## ORIGINATION FORM

### Proposed Revisions to a Standard Plans Index (Please provide all information — Incomplete forms will be returned)

Index Number: 102-665

Index Title: Limited Access, Temporary Opening

INDEX	SHEET
102-665	1 of 1

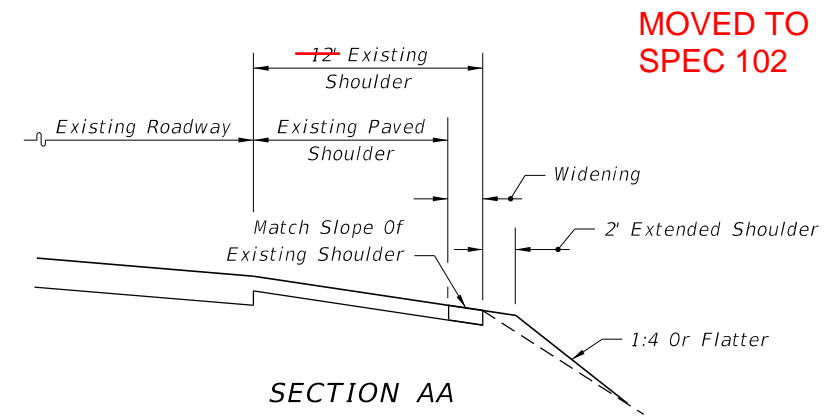
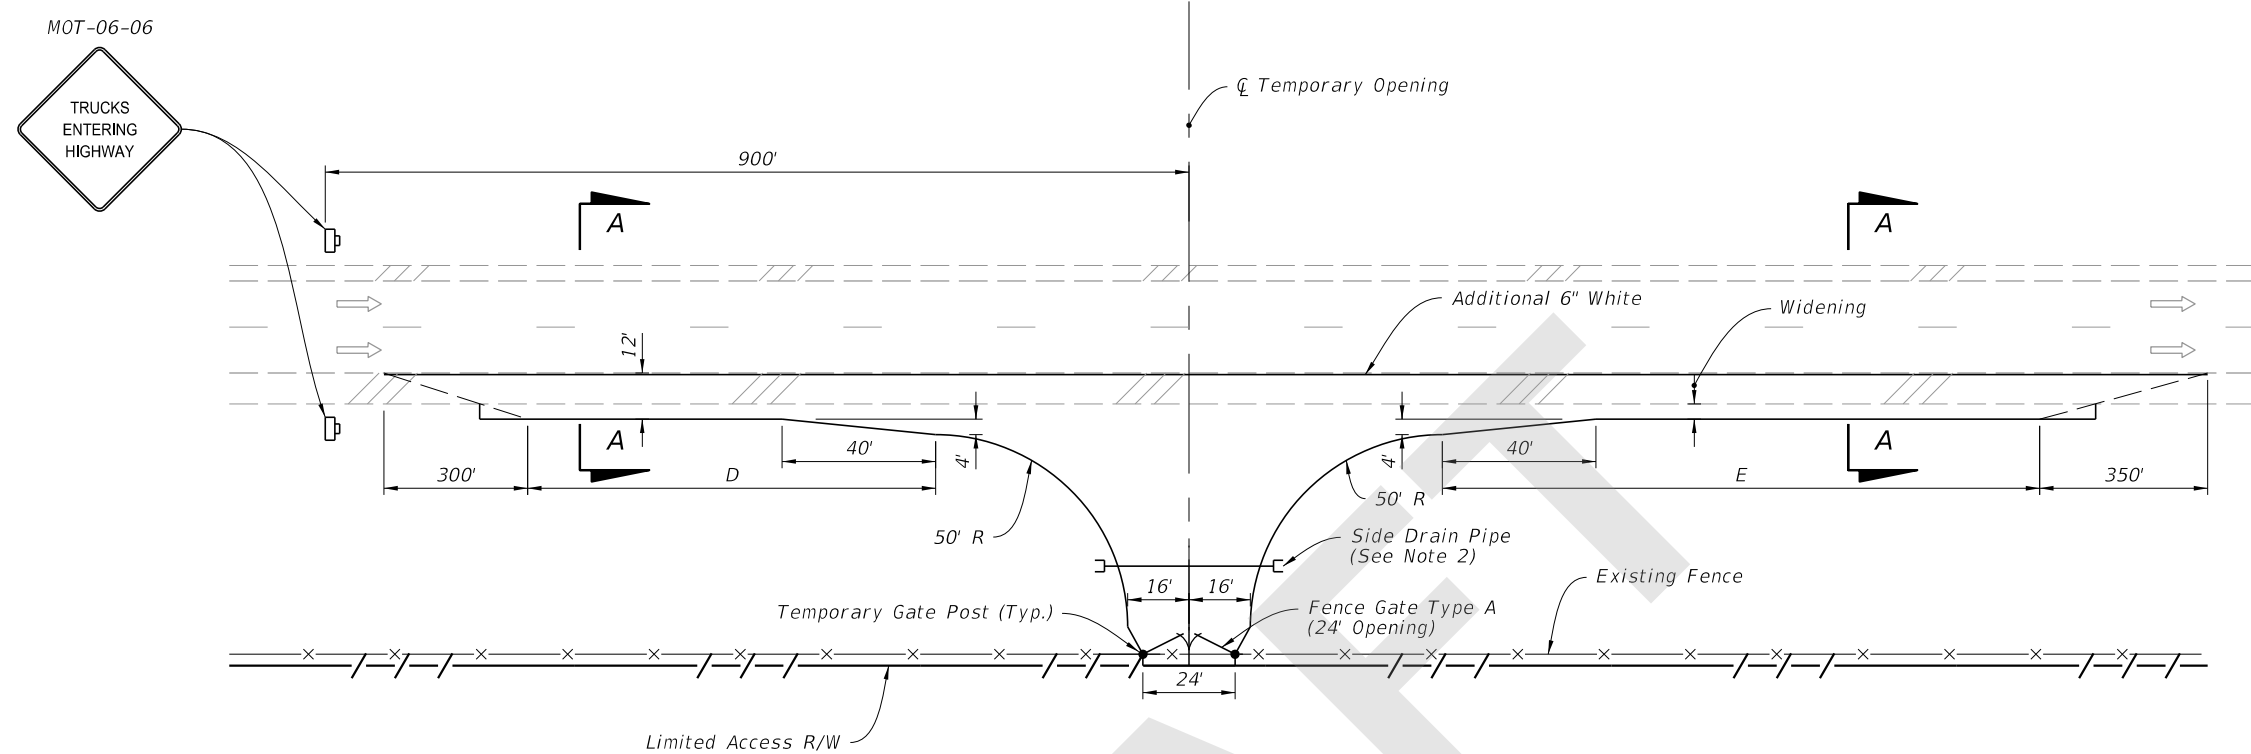
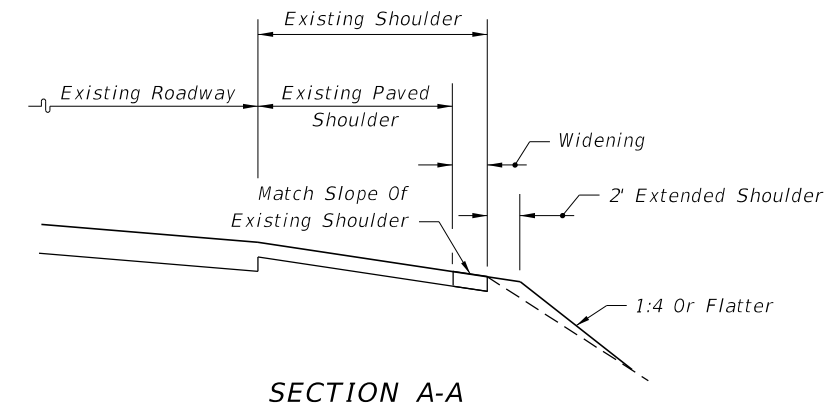
Sheet 1: Revised Details and Notes 1-3, 9 & 12; Updated Symbols; Deleted Notes 4 & 6; Moved Notes 5, 7, 8, & 13 to Spec 102.

REVISED DETAIL

MOVED TO SPEC 102

REVISED NOTES

MOVED TO SPEC 102

4. ~~Access openings shall not be constructed directly opposite temporary median crossovers nor within 2000 ft. of temporary median crossovers.~~
5. Access openings shall be within the project limits and shall not be used for transporting materials to or from any other project. The acceleration-deceleration surfaces shall be paved. RAP material is acceptable for driveway surfacing.
6. ~~Any Motorist Aid Call Boxes affected by the temporary access openings shall be relocated outside the limits of access lanes and remain in use during construction. Upon removal of access lanes, call boxes shall be returned to their previous location. Temporary relocation and restoration of call boxes shall be at the contractor's expense.~~

REVISED NOTES

UPDATED SYMBOLS

- NOTES:**
1. X = Work Zone Sign Distance, see Index 102-600 for "X" value.
  2. Use mitered end sections for any end sections within the clear zone.
  3. Match cross slope of existing shoulder for widening.
  4. Provide 2' of unpaved shoulder outside of the widening.
  5. No more than two (2) access openings will be allowed on each project.
  6. Do not vary from the plan detail without approval of the Engineer.

- SYMBOLS:**
- Work Zone Sign
  - Lane Identification and Direction of Traffic

LENGTH OF ACCESS LANES		
Grade	D (feet)	E (feet)
2% or less	590	1540
3 to 4% Upgrade	530	2310
3 to 4% Downgrade	710	925
